KNOXVILLE HISTORIC ZONING COMMISSION STAFF REPORT - CERTIFICATE OF APPROPRIATENESS APPLICATION

PROPERTY LOCATION: 404 E. Oklahoma Ave. /
Parcel ID 81 L P 008

FILE NO.: 11-G-19-HZ

PROPERTY DESCRIPTION: Folk Victorian (c.1910)

404 East Oklahoma
Plot Plan

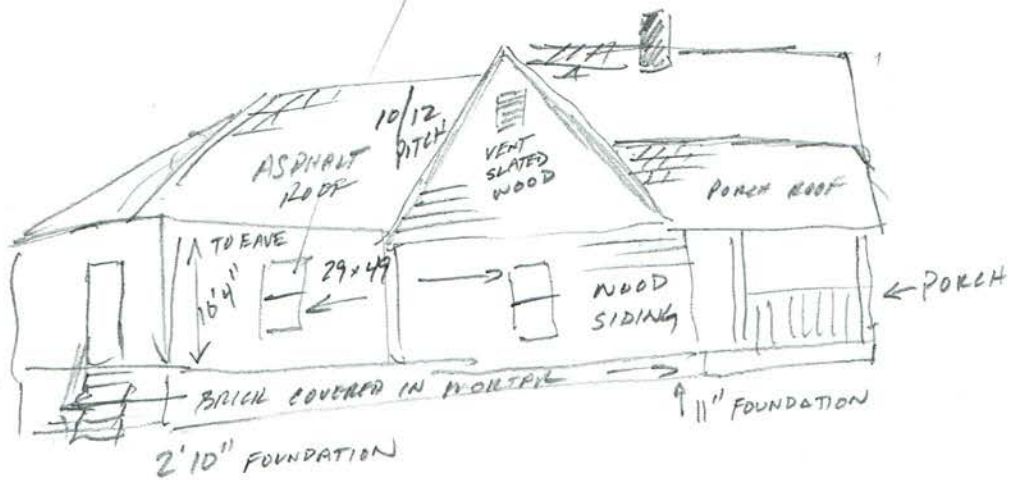
4. The proposed replacement Craftsman-style door is not appropriate for the style of the house.
5. Placement of the proposed addition at the rear of the house is appropriate. The one-story massing and materials, including wood siding, wood cornerboards, and wood double-hung windows are all appropriate within the guidelines. As proposed, the rear addition would continue the existing roofline and be flush with the existing walls. According to the guidelines, additions should be distinguishable from the historic building; a hyphen or offset of the exterior walls would suffice to distinguish the new construction from the existing house. More information is also needed on the placement and measurements of windows on the addition.

6. Guidelines state that windows "must retain the full height and width of the original opening." Evidence has not yet been provided that the window proposed for partial enclosure is not visible from the public right-of-way.

Staff recommends postponement of HZC review until the December meeting, so the applicant may provide more thorough information on the proposed porch work, addition, and chimney reconstruction.
